SERVICE BULLETIN

BULLETIN NUMBER: 175

MODEL: Diesel Generators WMD, BCD, BTD up to 12.5 KW and BTDA up to 12.5 KW

SUBJECT: Fuel Solenoid #023041 Circuit Improvement

Illustration of Circuit Breaker and Red Wire Lead
Between the
Preheat Solenoid and Fuel Solenoid

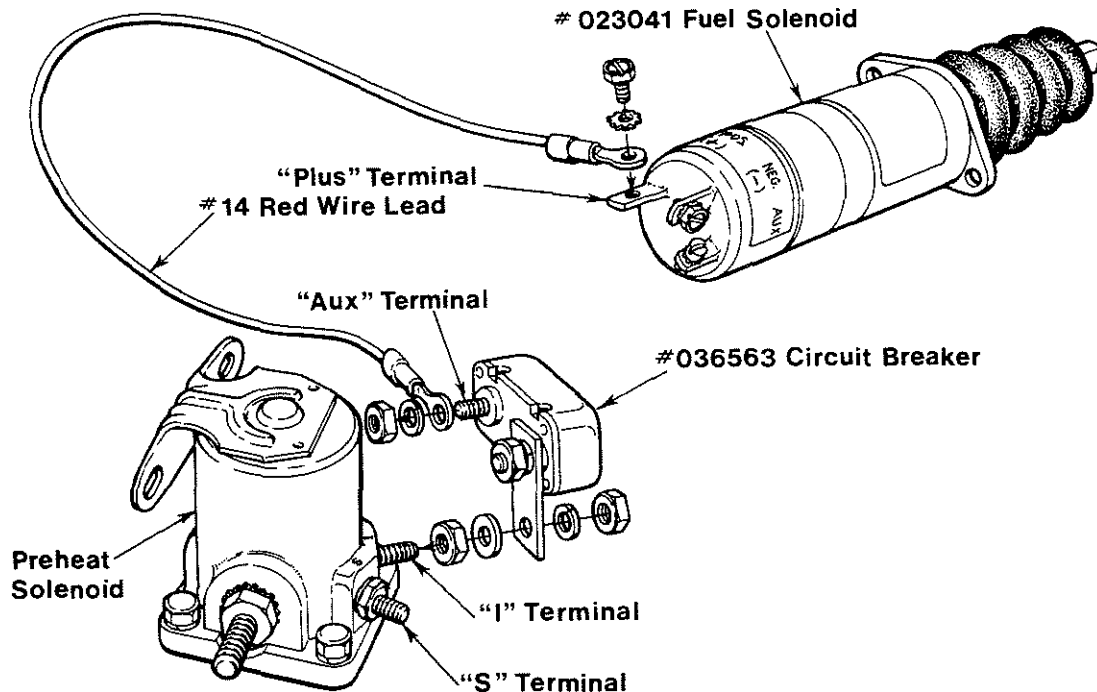
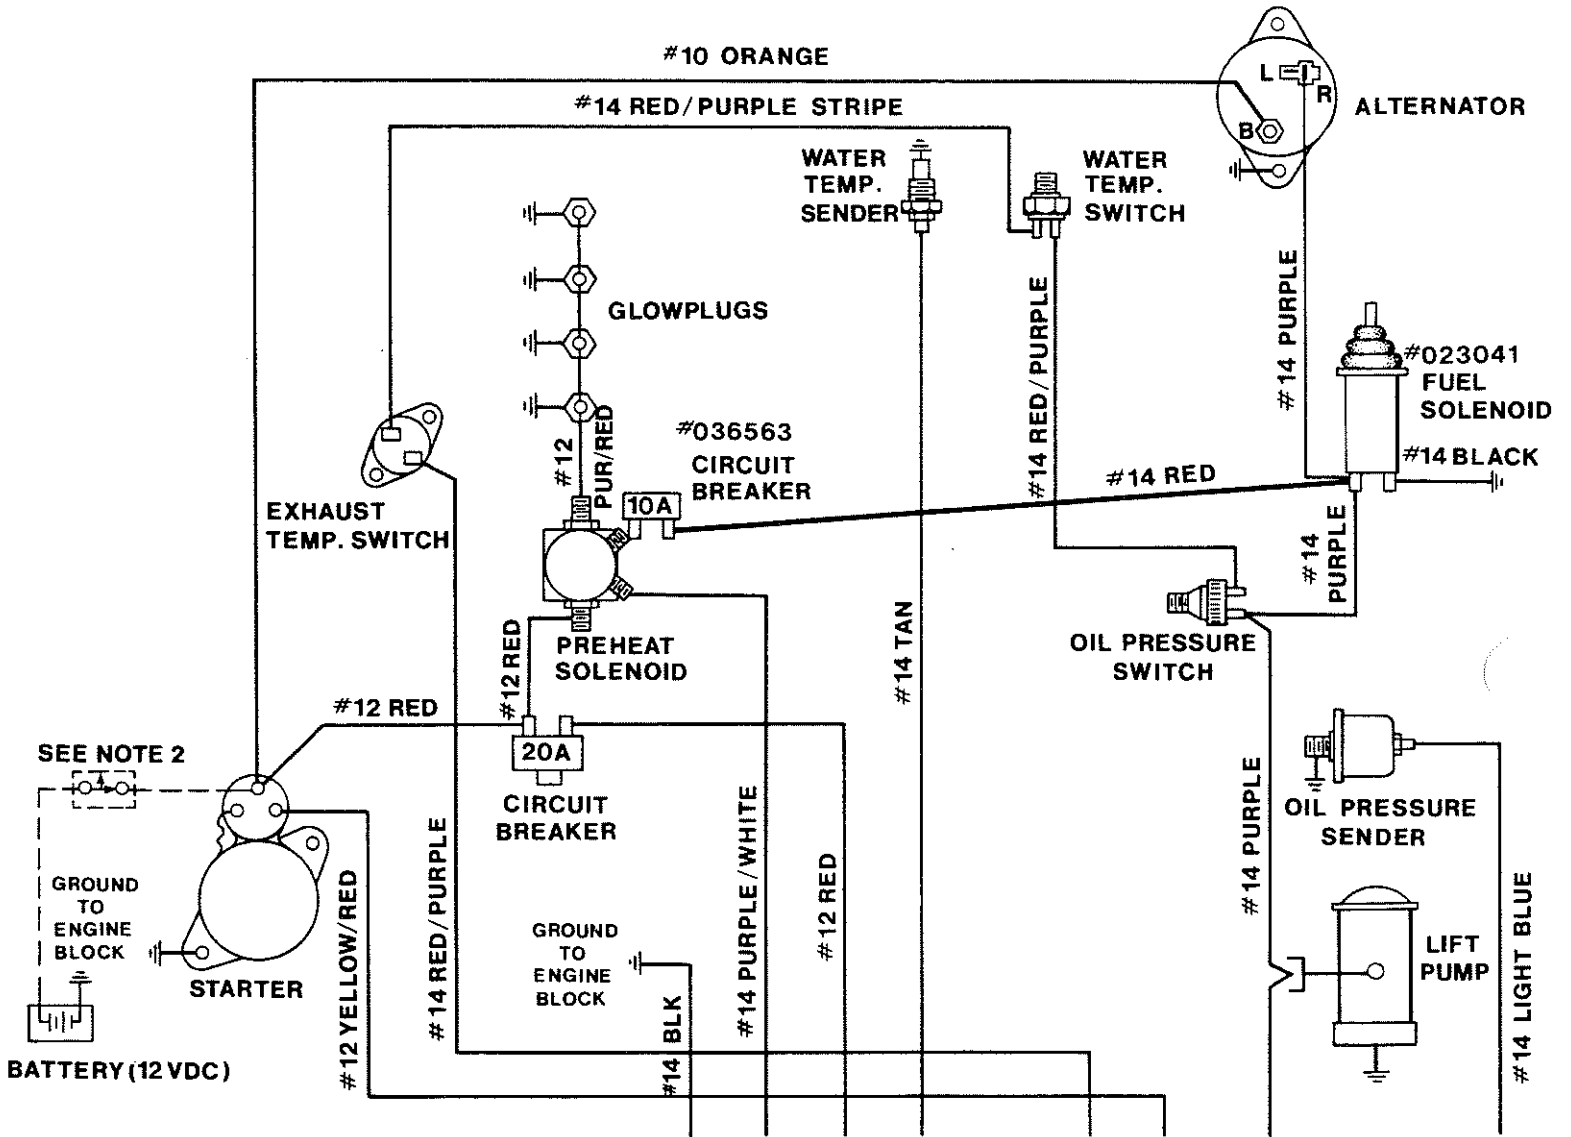
In an effort to prevent fuel solenoid failures that are the result of a voltage loss/reduction in the fuel solenoid circuit during "preheat" and "start," this circuit is now energized using battery voltage available at the "I" terminal on the preheat solenoid when this solenoid is energized during "preheat."

Early model WMD, BCD, BTD and BTDA units up to 12.5 KW can incorporate this circuit by installing circuit breaker assembly #036563 to the vacant "I" terminal of the unit's preheat solenoid and running a #14 red wire from the "aux" terminal of the circuit breaker assembly over to and connecting with the leads presently attached to the "plus" terminal of the fuel solenoid #023041. Ensure this wire is secured and protected against chafing and engine hot areas it passes near.

The wiring diagram, on the reverse of this page shows this circuitry being installed on earlier model diesel generators as listed above.

NOTE: The "I" terminal 10 - 32 threads, circuit breaker connection #10 terminal end for #14 wire, fuel solenoid (plus) terminal #8 terminal end for #14 wire, and #14 wire - length as required.
